UNITED STATES PATENT AND TRADEMARK OFFICE

APPLICATION NO.	FILING DATE	FIRST NAMED INVENTOR	ATTORNEY DOCKET NO.	CONFIRMATION NO.
09/374,681	09/19/2002	CRAIG H. BAKER	81762/210	4027

Office Action Summary

DETAILED ACTION

ATTACHMENT

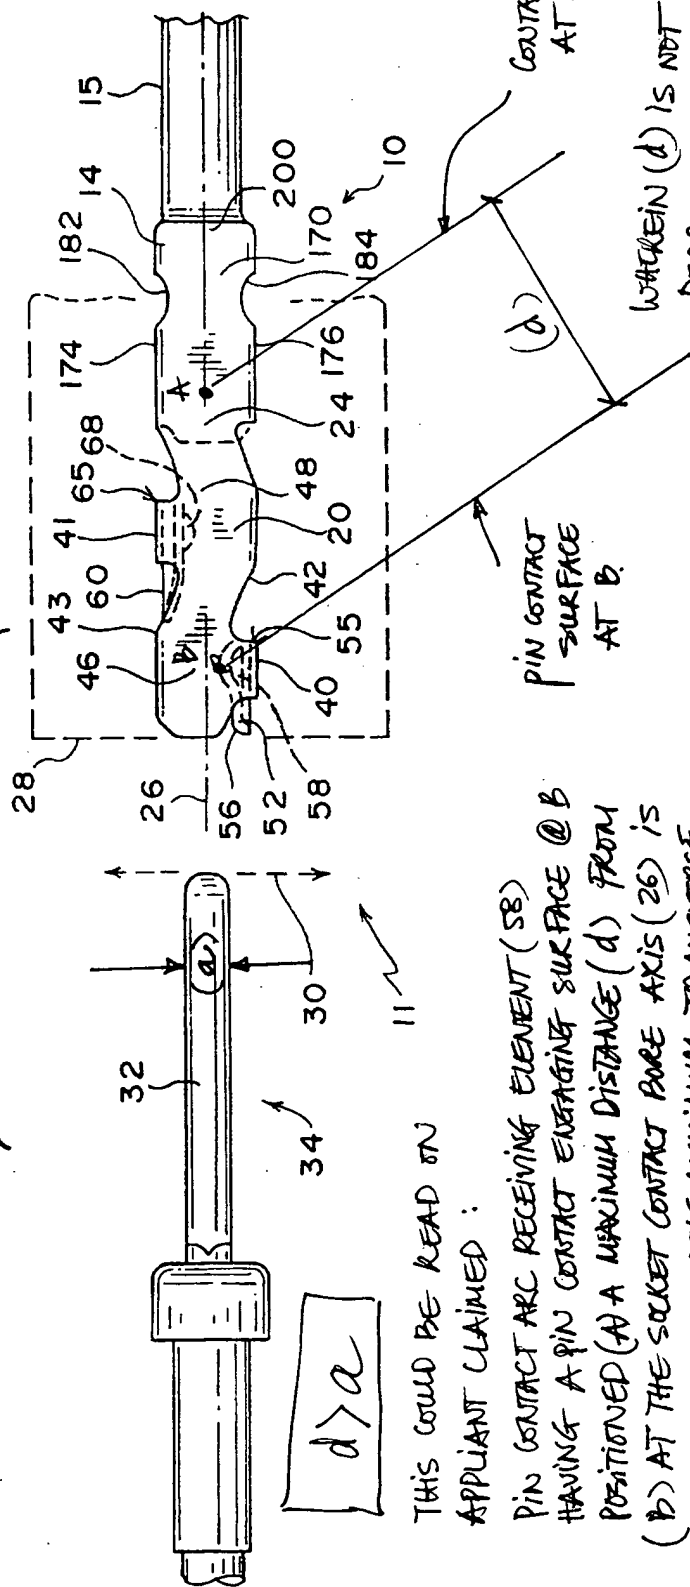
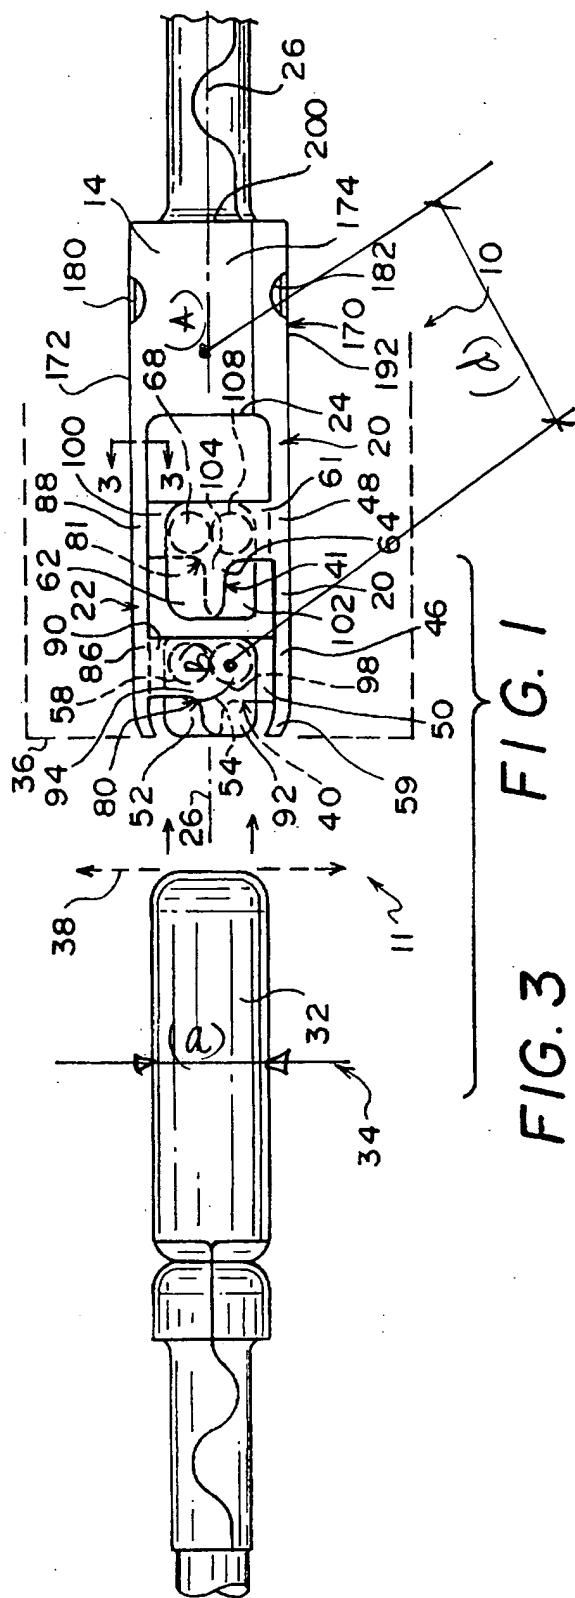
- an electrically conductive barrel body [figure 4] having a pin contact engaging axial bore along a socket contact axis [26];
- two forward edge portions [50, figure 2] integrally formed in the body are read on applicant's at least two integrally formed pin contact arc receiving elements upon the connecting and disconnecting of the pin contact and the socket contact;
- two flexible tabs [40, 41, figure 2] integrally formed in the body are read on applicant's a plurality of integrally formed, cantilevered spring contacts; and
- the pin contact arc receiving elements having a pin contact engaging surface position [58] at a maximum distance from the socket contact axis that is greater than the maximum transverse dimension of the pin contact [see attachment for examiner's interpretation].

THIS COULD BE READ ON

APPLICANT CLAIMED :

PIN CONTACT ARC RECEIVING ELEMENT (SB)
HAVING A PIN CONTACT ENGAGING SURFACE @ B
POSITIONED (A) A MAXIMUM DISTANCE (d) FROM
(B) AT THE SOCKET CONTACT BORE AXIS (26) IS
GREATER THAN THE MAXIMUM TRANSVERSE
DIMENSION OF PIN CONTACT (34)

PIN CONTACT
SURFACE
AT B.

AT A
OUTLET

WATERIN (d) IS NOT
PERPENDICULAR TO (26)
